| Title - Sujet Mechanical System Upgrade for North Modernisation du système mécanique des ailes nord et sud | |
| Solicitation No. - N° de l'invitation EZ899-222066/A | Amendment No. - N° modif. 002 |

This Amendment 002 is raised to issue Addendum 001.

- .1 Ships Ladder Crossover Sample Drawing (provided by contractor for information only. Not for construction)
.2 Roof Barrier Sample Drawing (provided by contractor for information only. Not for construction)

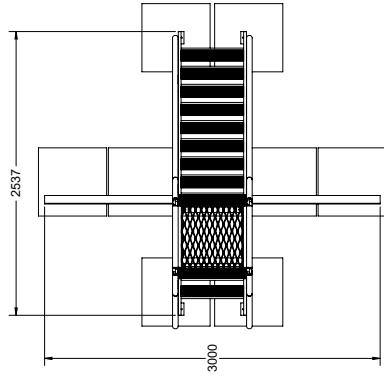
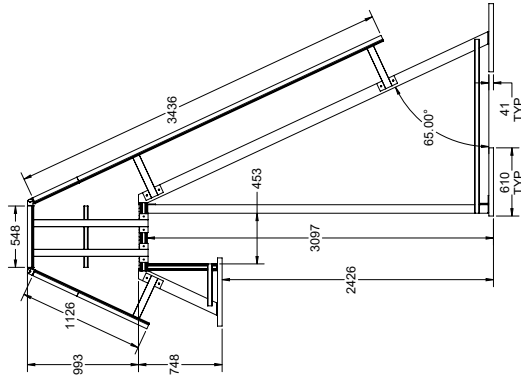
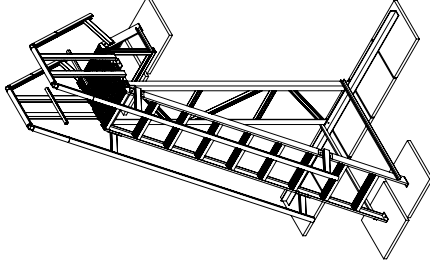
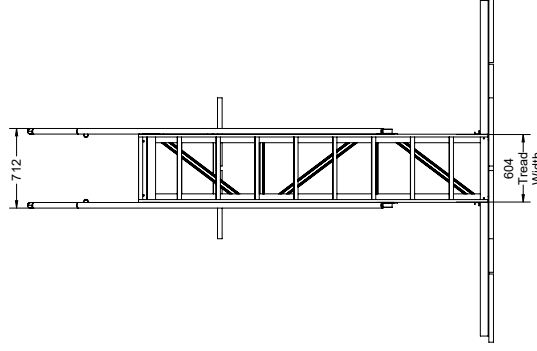
- .1 Q.: Request for approval of the following products:
- a. Modular aluminum ships ladder
 - i. The system comes in modular components and is assembled on site

- ii. It can be designed to be non-penetrating/ballasted, reducing cost of install and eliminating any structural tie-ins
 - iii. It is aluminum – will not rust over time, and is more light-weight so is more cost effective to install

- iv. We provide site specific shop drawings 1 week from an order being placed
 - v. We have material in stock, and fabricate in max 4 weeks from signed approved drawings

Response: Above proposed systems appear to be:

- a. architecturally acceptable provided that complete information including but not limited to size of handrail, guardrail diameter, base plate size, attachment to the roof, etc. in a proper shop drawing are provided; and
- b. structurally acceptable, as long as it will be designed and shop drawings sealed by a structural engineer (P.Eng.) registered in BC.

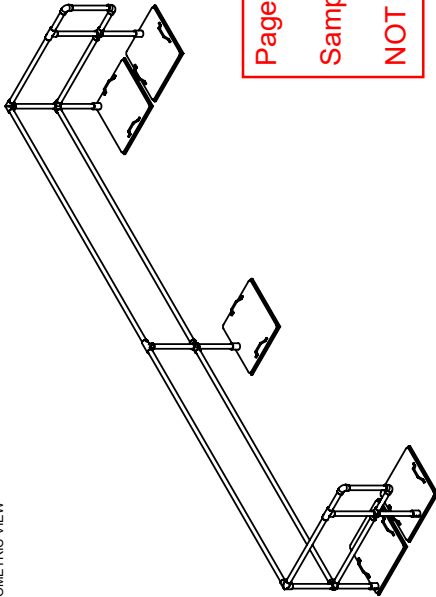
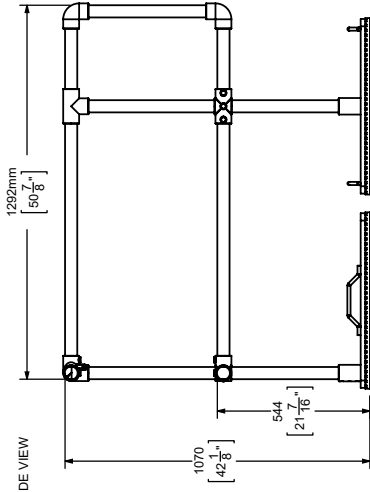
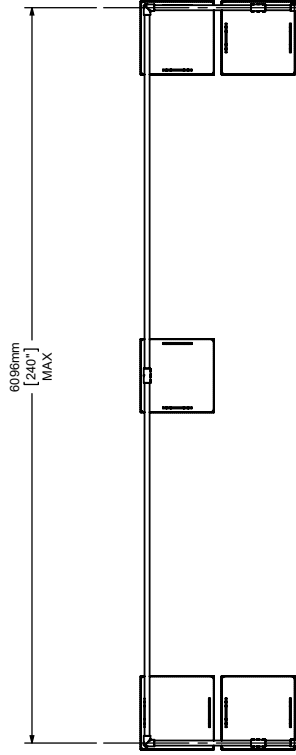
- b. 5001 series modular Roof Barrier guardrail
 - i. The system is ballasted/non-penetrating
 - ii. It is pre-engineered and pre-manufactured, equalling a faster lead time and simpler installation

- iii. It comes with the posts pre-assembled equalling 50% time savings on install
 - iv. We provide site specific shop drawings 2-3 days from an order being placed

- v. We have it in stock and would ship 2-3 days from signed approved drawings
 - c. sample drawings of both systems are attached.
